# TECHNICAL BULLETIN

## Hood Liner – Modification – Service Action S437

**76-105**

MODEL XJ12 1994 MY

ILLUSTRATION 1

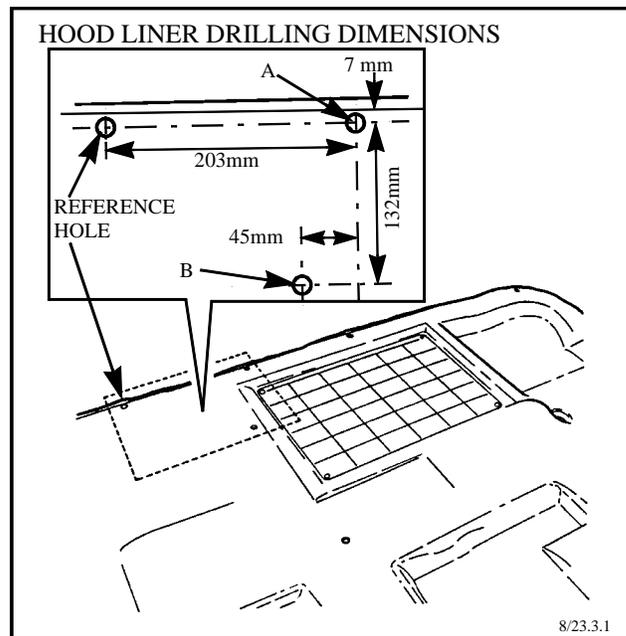
4. Mark the liner for two new 5/16" (8mm) holes, A and B (Illustration 1).

ILLUSTRATION 2

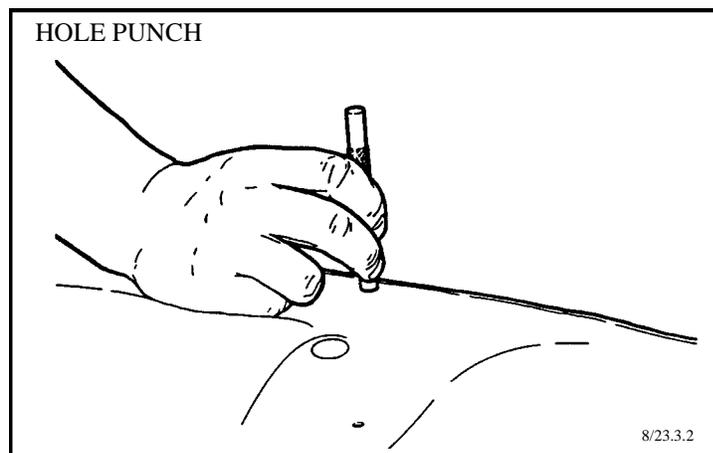
5. With a "wad punch" or similar tool, punch two, clean, 5/16" (8mm) holes as indicated.

ILLUSTRATION 3

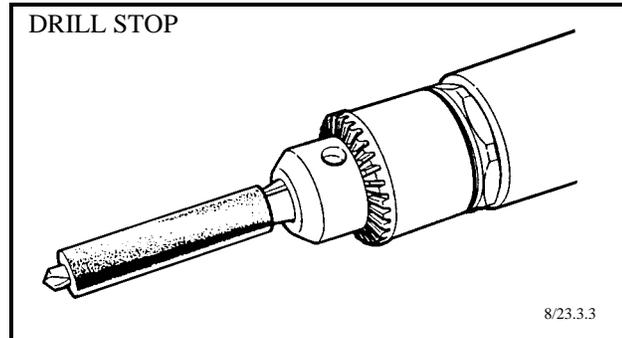
9. Fit a drill stop or a length of hose on a 15/64" (6mm) drill bit to control the hole depth to approximately 3/16" (5mm).

**CAUTION:** The drill must be controlled so that the drill bit cannot contact the inner side of the hood panel.

10. Drill the two new 15/64" (6mm) holes. Deburr the holes and paint any bare metal with a zinc-rich anti corrosive paint.
11. Install the hood liner starting along the top edge. Maintain proper alignment to ensure that no sagging occurs as the rivet screw assemblies are installed. Install two new rivet screws in the new holes.
